**Consumers
Power
Company**

DOCKET 50-255 - LICENSE DPR-20 -
PALISADES PLANT - ADEQUACY OF STATION ELECTRIC DISTRIBUTION
SYSTEM VOLTAGES ADDITIONAL INFORMATION

Attachment I

Responses to Additional Information Requests from NRC
Letter dated June 24, 1981

FIGURE 1
PALISADES-ACCELERATION TIMES
OF EMERGENCY MOTORS

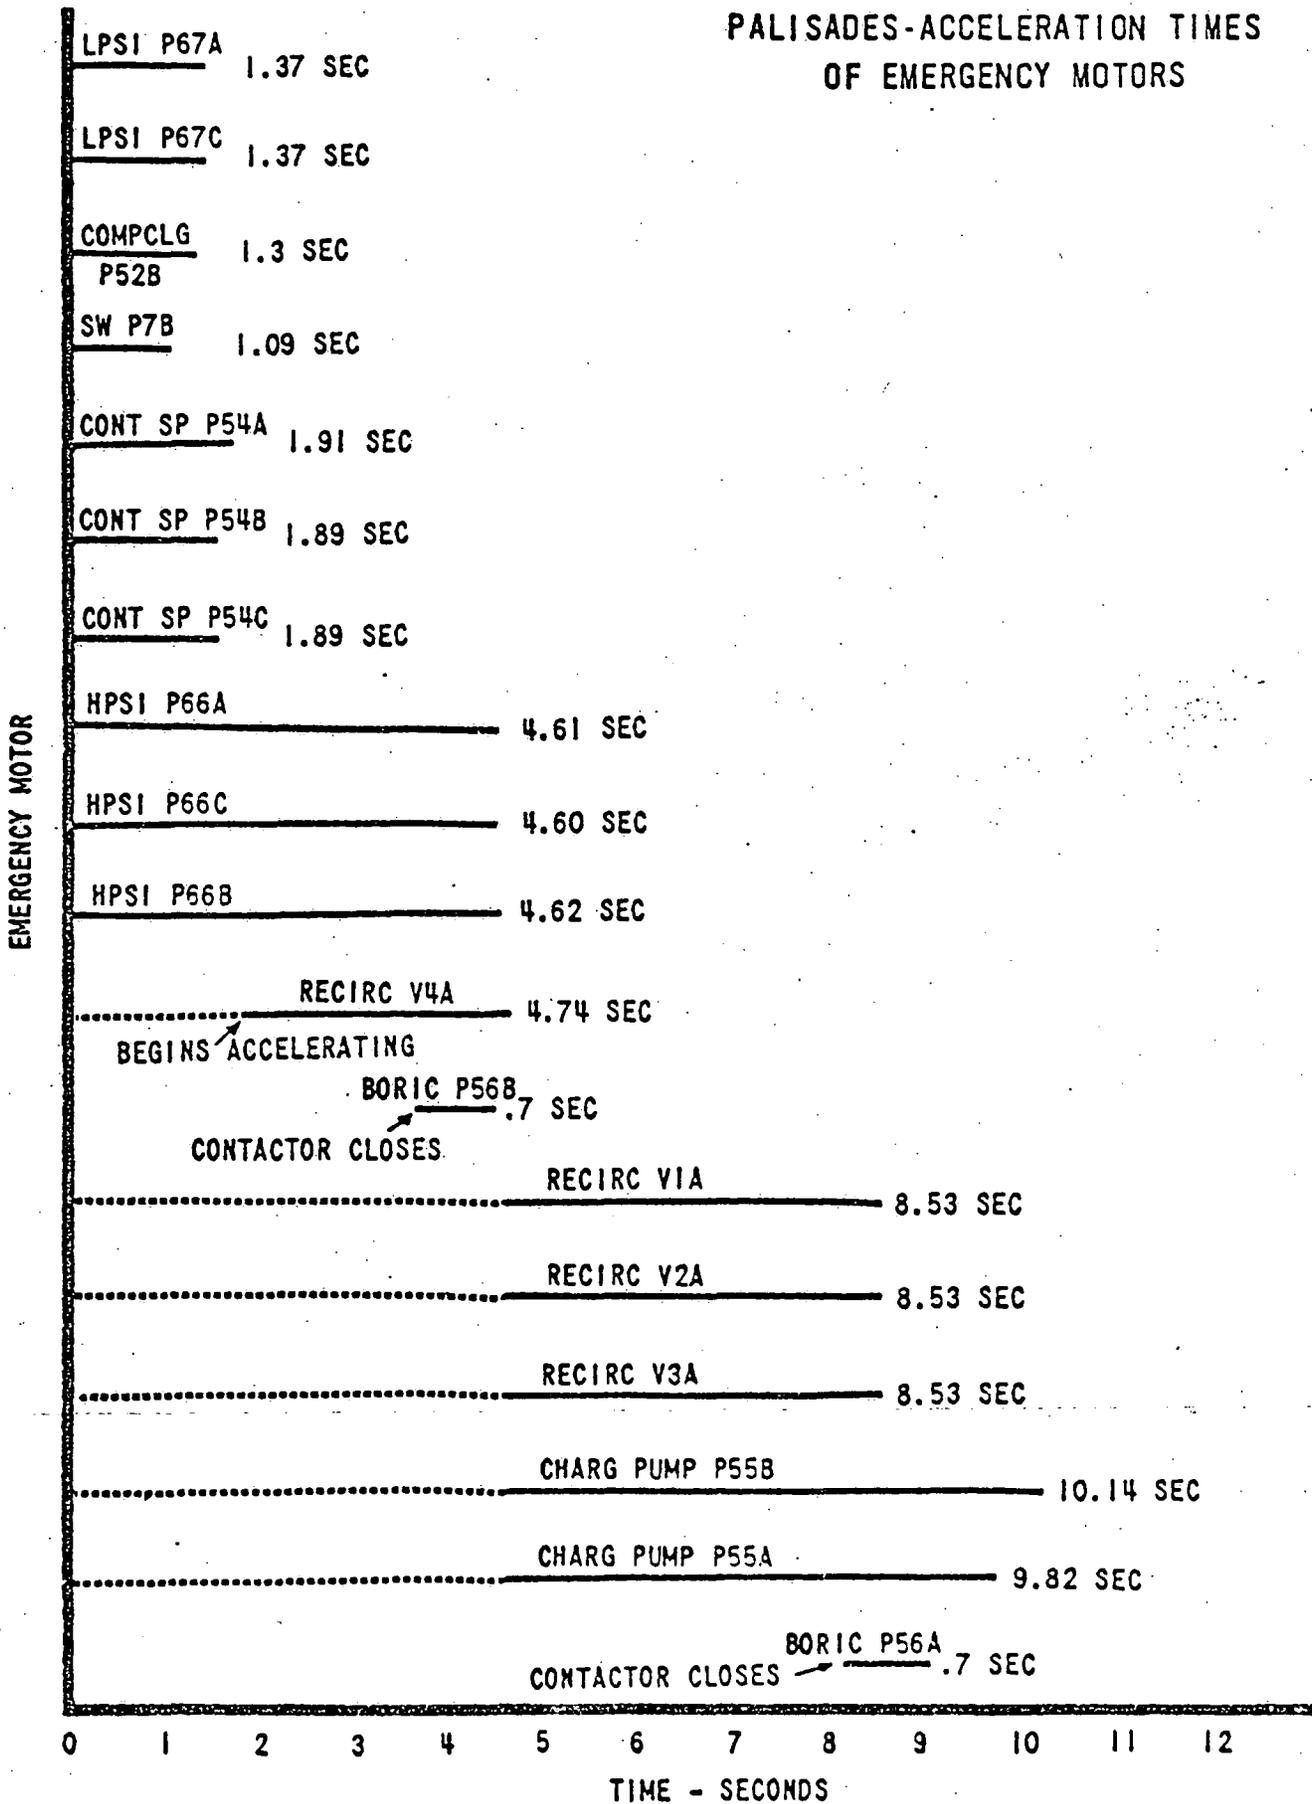
1. CPCo has shown in the speed torque curves that the majority of the Class 1E motors will start, under load, when the motor terminal voltage is 70%. Verify that all Class 1E loads will start when the motor terminal voltage is 70% (or some other specified level) and deliver the capacity required to mitigate the consequences of an accident.

The speed torque curves, which were submitted in CPCo letter dated March 3, 1981, show that the 2400V motors will start and operate the required load when the motor terminal voltage is at or above the value shown in Table I of this submittal. The 480V containment cooling fan motors have been earmarked for replacement as a result of environmental qualification requirements which cannot be met by the existing motors. These motors will be designed and tested to start and operate under load conditions at 70% voltage.

FIGURE II
DALLAS/DADES
2400 VOLT BUS JUNCTION
UNDERVOLTAGE RELAYING

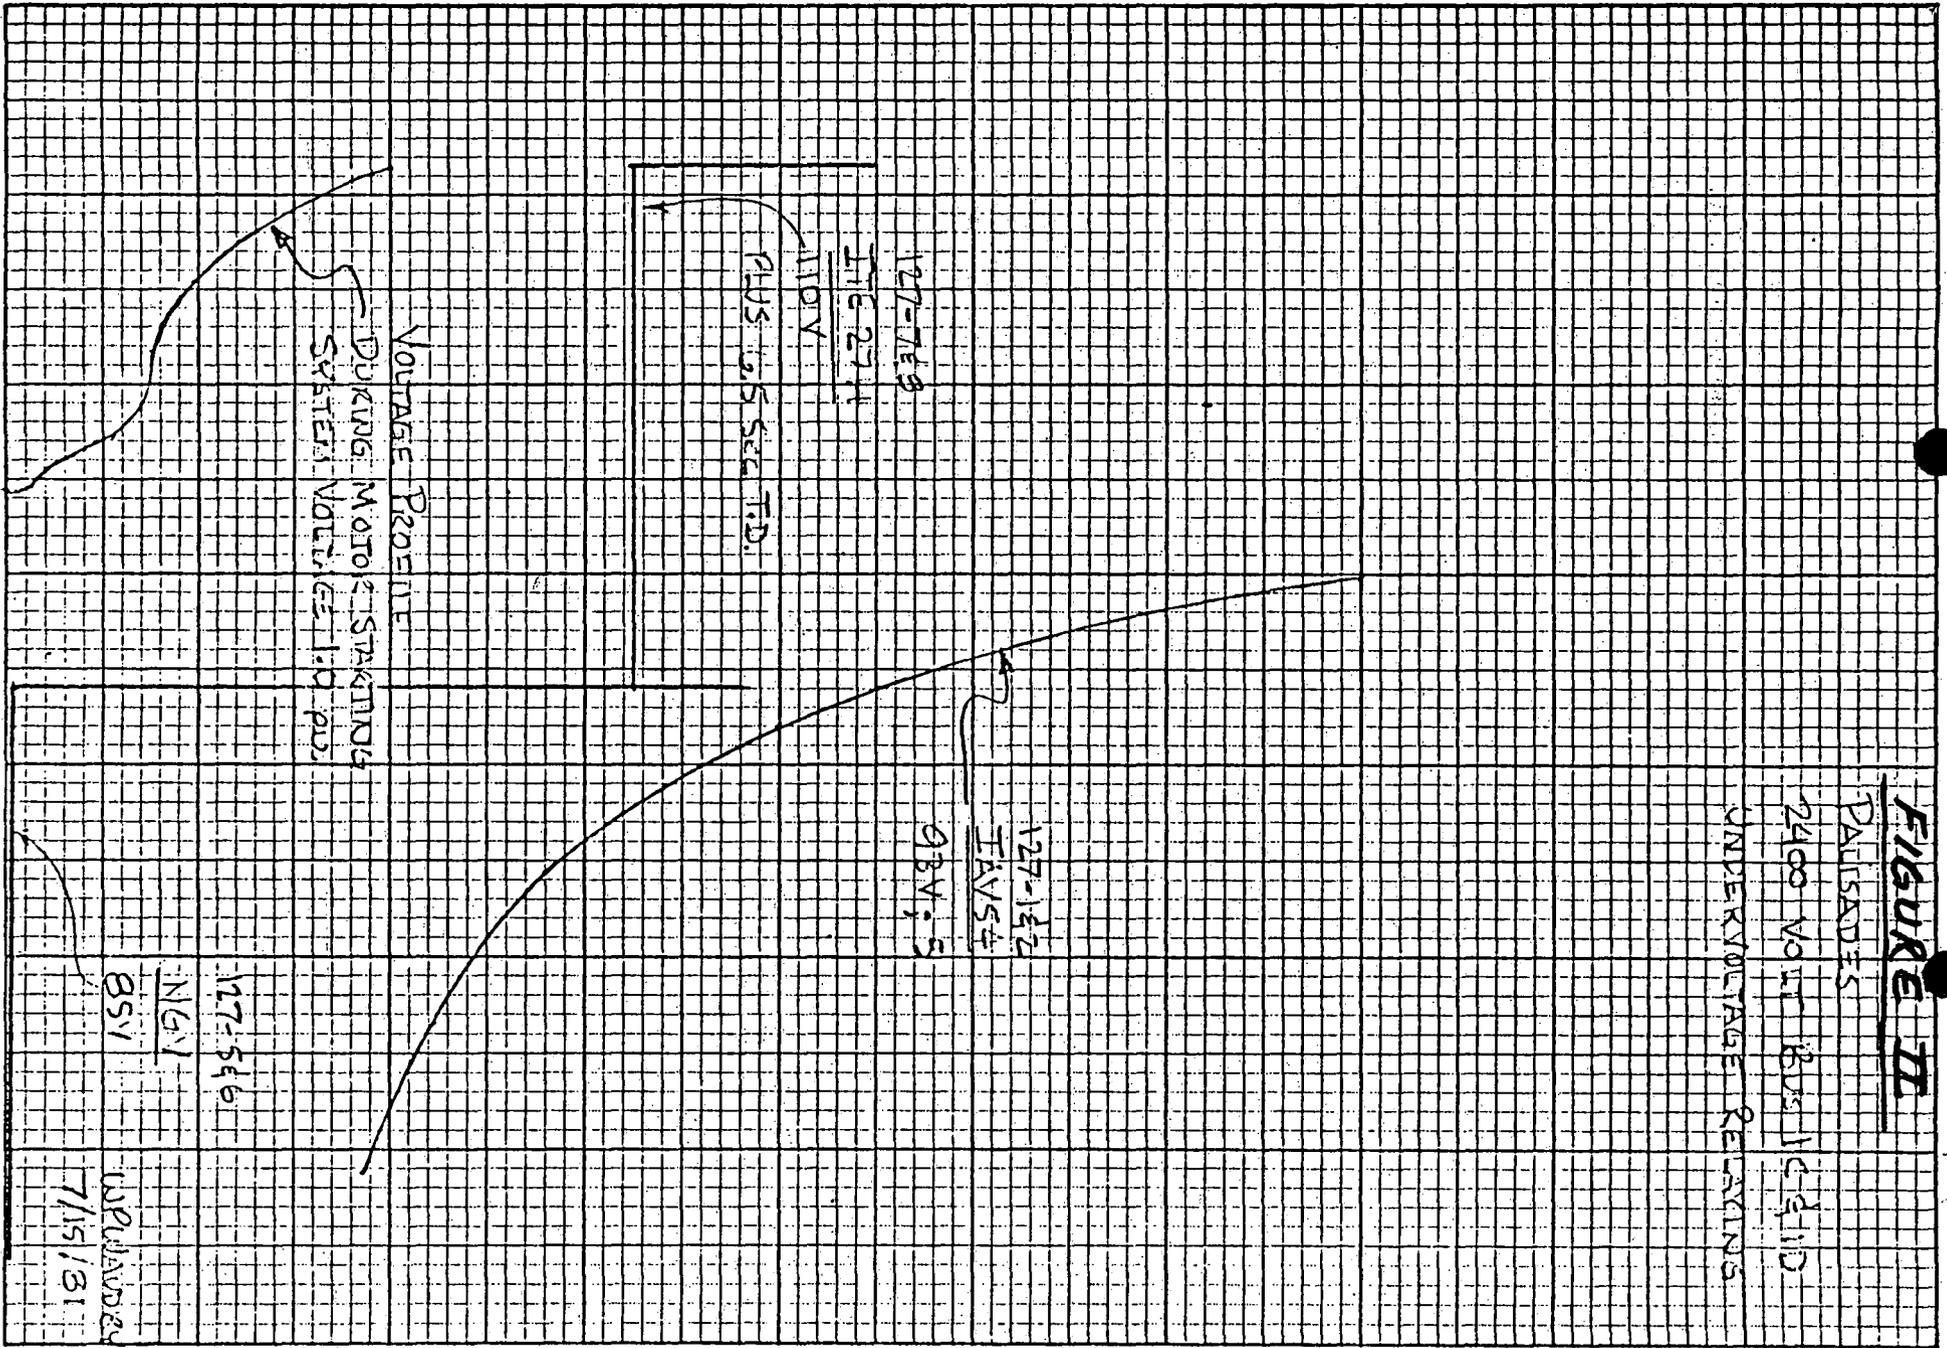
2. CPCo has shown that the 460V and 440V motors and the 480V battery chargers do not have sufficient voltage to operate continuously with maximum unit loads concurrent with the offsite grid at 95% of nominal. Moreover, the voltage at the 480V contactors is less than that required to pick up additional loads that may be required by an accident.

Based upon the above, either demonstrate that our findings are not correct or provide proposed modifications and schedules to correct these deficiencies.

The degraded grid voltage relay setpoint ($91.4\% \pm 0.13\%$) is higher than the minimum expected continuous operating voltage for 2400V buses 1C and 1D (87.3% of 2400V). The loss of voltage relay setpoint ($77.5\% \pm 3.3\%$) is higher than the minimum analyzed motor starting transient. Based on the CPCo submittals, it is not evident that the time delay for either the degraded grid voltage relays or the loss of voltage relays is sufficient to ride through all expected motor starting transient dips when the grid is at 95% and the unit loads are maximum. It appears that there may be potential for spuriously separating the Class 1E buses from the offsite source by operation of either the loss of voltage or second level under-voltage relays.

The 2400V system is protected by three separate undervoltage relays of different types and settings. These types and settings were previously submitted, but for clarity, Figure II is being submitted again to show the actual time vs percent voltage for the three relays combined. Also shown on Figure II is the voltage vs time profile for the worst case loading of the emergency busses with the system voltage at 100%. The value for 100% should be used as explained above instead of 95%.
